12255
8 June 2017

**SECTION 96(2) MODIFICATION APPLICATION SSD 7388 – MOD 3
31 WHEAT ROAD, SYDNEY**

On behalf of Grocon (Darling Harbour) Developments Pty Ltd we hereby submit an application pursuant to section 96(2) of the *Environmental Planning and Assessment Act, 1979* (EP&A Act) to modify SSD 7388 relating to The Ribbon development (former IMAX site).

Figure 1 – Original DA Concept and Refined Podium Concept

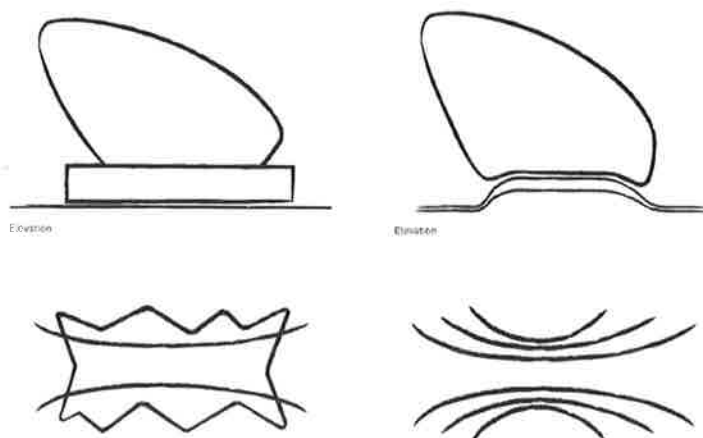
Hassell has reviewed the design of the podium envelope to better align the geometry of the tower with the podium. The DA concept may be interpreted as a vertically curling ribbon (tower) resting upon a horizontally undulating ribbon (podium), the proposed developed concept strengthens and reinforces this idea further by aligning the geometry of the tower and podium. In this way, the composition may be read as a series of sweeping, dynamic curves that re-interpret the lines of the western distributor overpasses into a shape that simultaneously creates a strong focus at its centre (the hotel main lobby and atrium) while reaching out towards the public domain and Darling Harbour beyond. The nested, projecting curves of the podium form also cleverly negotiate the complex offsets from the RMS overpass structure, optimising the interior floor area and rationalising the shapes of the rooms and improving their visual connectivity to the harbour.

'The changes to the podium levels of the Ribbon proposed in this Section 96 are a direct consequence of the building's change in use from commercial office to hotel. As a commercial office building, the podium functions were entirely separate from the tower functions. This condition informed an architectural response that sought to separate the tower and podium forms, giving them distinct and contrasting identities. As a hotel, the podium and tower functions are much more interrelated. The eastern end of the podium forms the first point of contact that visitors have with the hotel and level one accommodates the front-of-house reception and principal guest gathering space. The podium is now both literally and symbolically supporting the tower - indivisible from it in function and forming a defining feature of the guest experience. As a consequence, the architectural response has been modified in this proposal to more closely associate the two building forms. It achieves this by extending the architectural language and geometry of the tower into the podium.'

The conceptual approach to the Ribbon may be abstracted as a series of nested curves that respond to the shape of the roadways that form the northern and southern site boundaries. The proposal for the podium extends these curves into the horizontal plane under the roadways, radiating outwards and embracing a sculptural and grandly proportioned hotel entry to the east, an elevation of curved glass that addresses Darling Harbour to the north and a more solid, grounded mass forming a unique identity for the lmax entry to the west. The proposal also improves the building's relationship to its context. The gentle sweep of the northern elevation deftly organises the plan around the pylons supporting the overpass while capturing the pedestrian movement from the promenade north of the site and redirecting it towards the west. This arc responds to the shape of the harbour's edge forming a legible southern boundary wall to the Cockle Bay foreshore public domain. In this way, when read as a whole, the composition of tower and podium will achieve a more consistent and elegant balance, befitting this site and this program.'

Figure 2 – Revised tenancy configuration
Source: Hassell

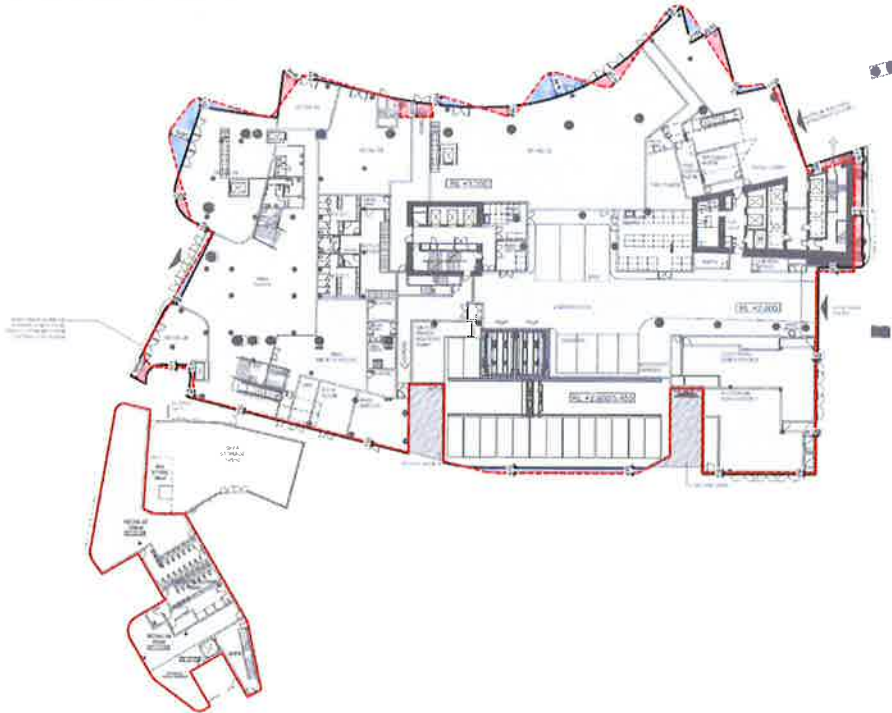
The revision of the building envelope necessitates the reconfiguration of the retail tenancies within the podium. The revised layout is shown in **Figure 2**. The proposed amendments increase the gross floor area(GFA) of the development by 107m² refer to the GFA calculations on drawing ARC-HSL-DD-SK-532.1.

Figure 3 – Comparison of approved and proposed footprint of the podium
 Source: Hassell

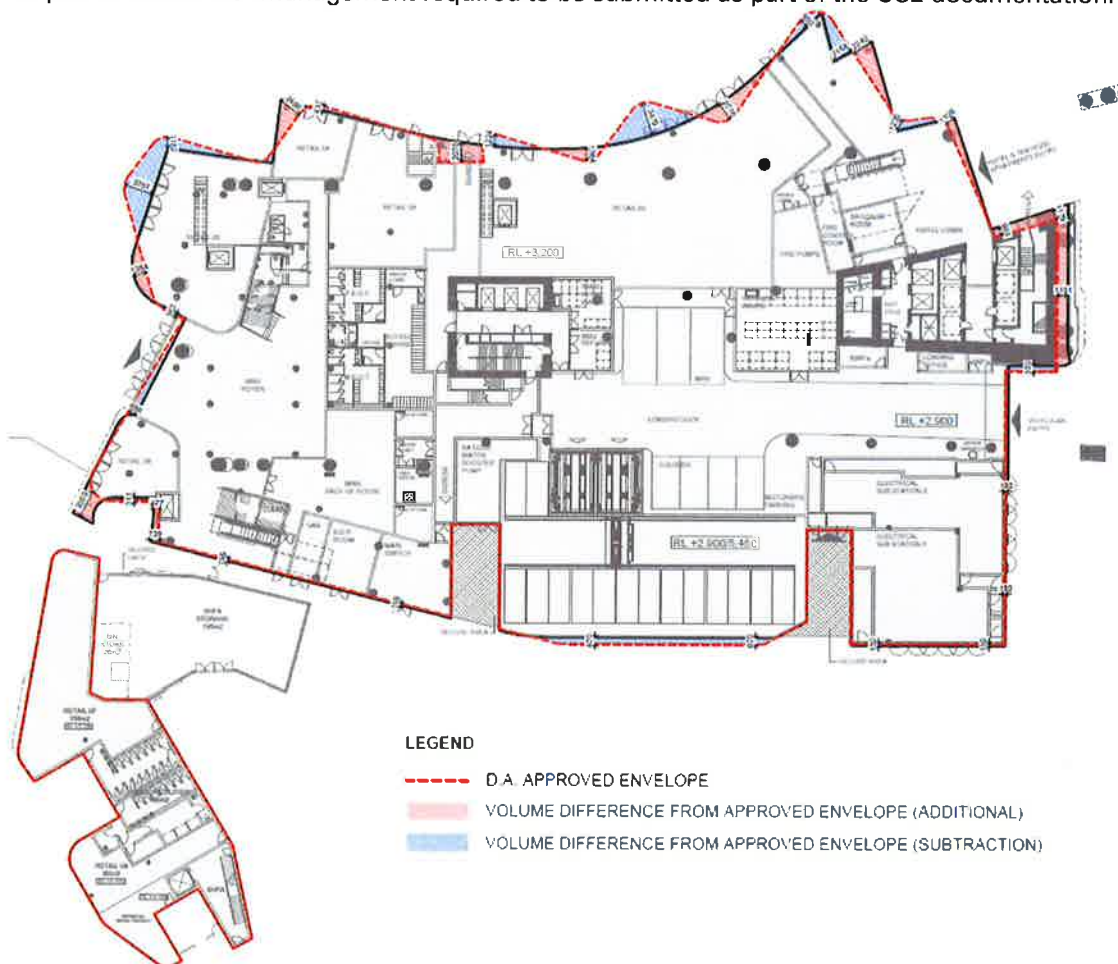
The proposed modification seeks to alter the podium envelope to provide a better design relationship with the tower form above and also the surrounding built form context. The revised design is the result of further design development and is cognisant of the key issues which were considered in the original assessment, being:

Figure 3 provides a comparison of the approved and proposed podium footprint. As can be seen in the image the revised design generally occupies the same area as that originally approved. It also maintains the important sightlines that were identified in the assessment of the original proposal as demonstrated in **Figure 4**.

The proposal does have an impact on the width of the pedestrian paths along the eastern edge of the podium. Following technical design development the structural columns now terminate to the core base and have increased in size. In order to improve the aesthetics of this element of the building, Hassell is now proposing to enclose the structure within the building envelope. Whilst it is recognised that such dimensions fall short of the desired width of 4.5m, they do exceed those specified as part of the approved development.
